Gouvernement du Québec

O.C. 939-2009, 19 August 2009

**Construction Code
— Amendments**

Regulation to amend the Construction Code*

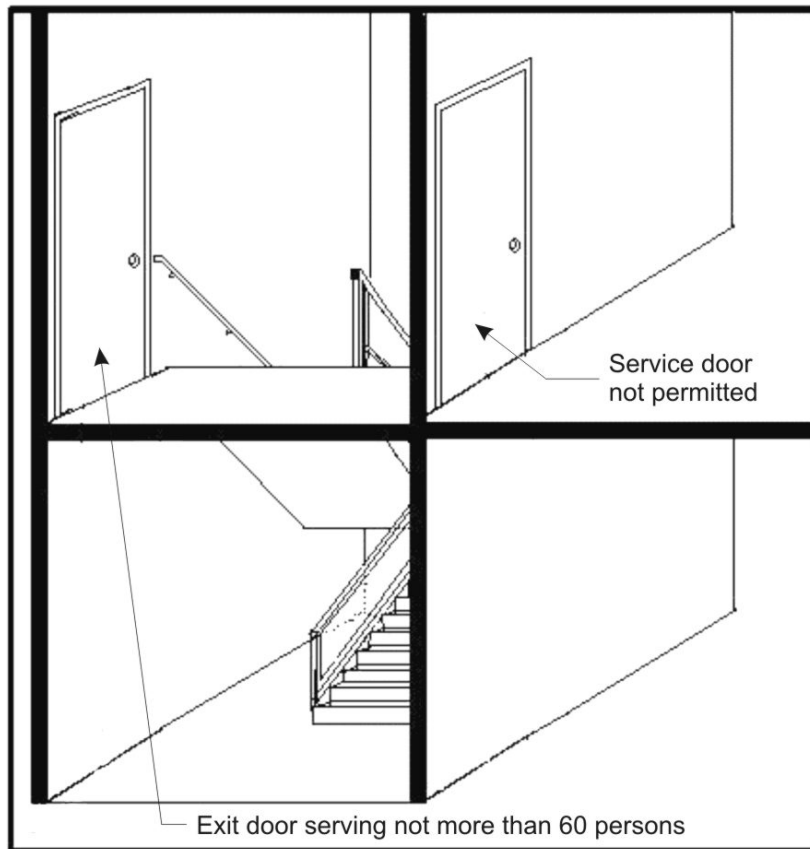
“**A-3.4.2.1.(2) Minimum Number of Exits.** When the only exit is separated and leads to the outside at a level other than the level it serves, no other access door shall be installed at that exit at a storey other than the storey served. This requirement is necessary to reduce the risk of smoke filling the only exit serving the floor area or parts of floor areas having access to that only exit. (See Figure A-3.4.2.1.(2).);

Figure A-2.4.2.1.(7) and (8)
Suds Pressure Zones Connections.”;

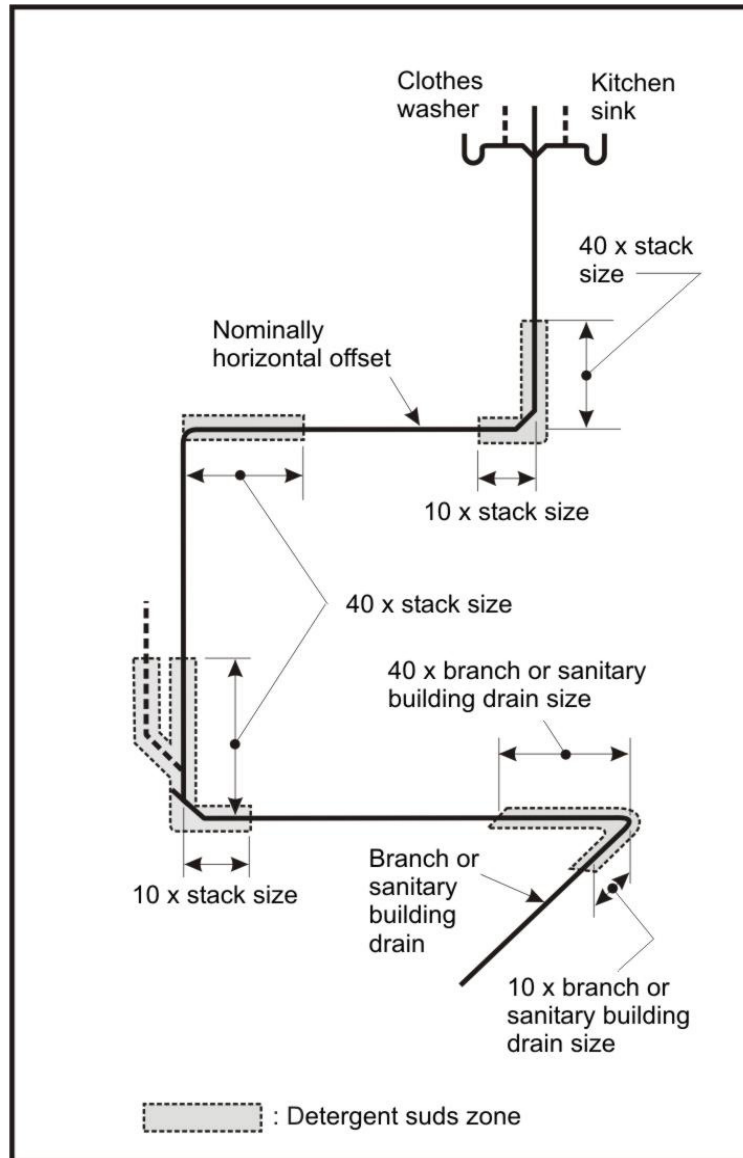
(8) by replacing note A-2.4.2.1.(7) in paragraph 39 by the following:

“A-2.4.2.1.(7) and (8) Suds Pressure Zones Connections

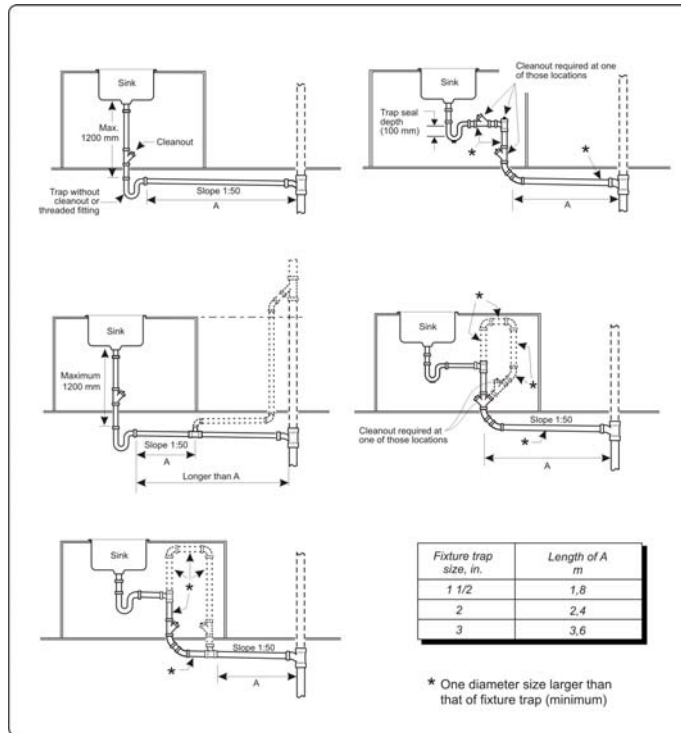
(9) by replacing Figure A-2.4.8.2.(1) in paragraph 45 by the following:

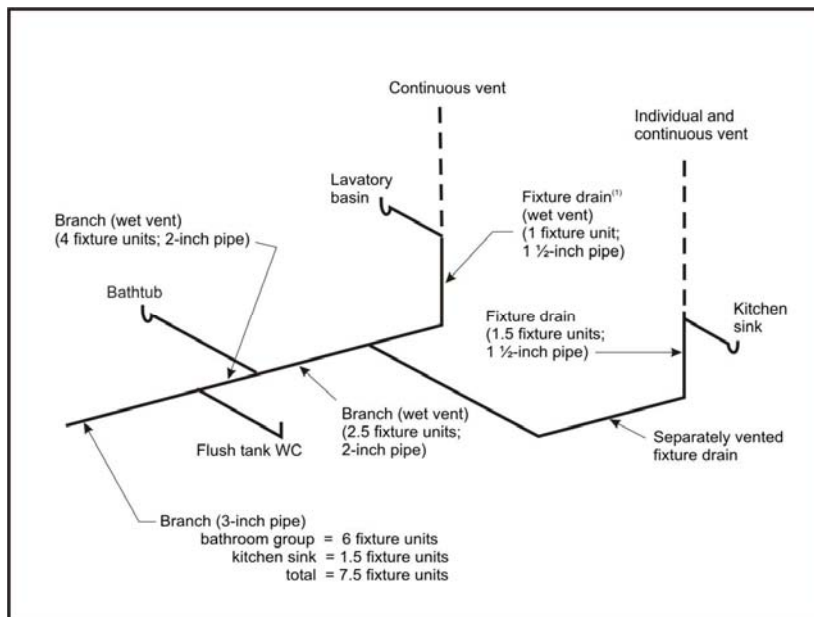
(10) by replacing Figure A-2.5.2.1. in subparagraph b of paragraph 46 by the following:
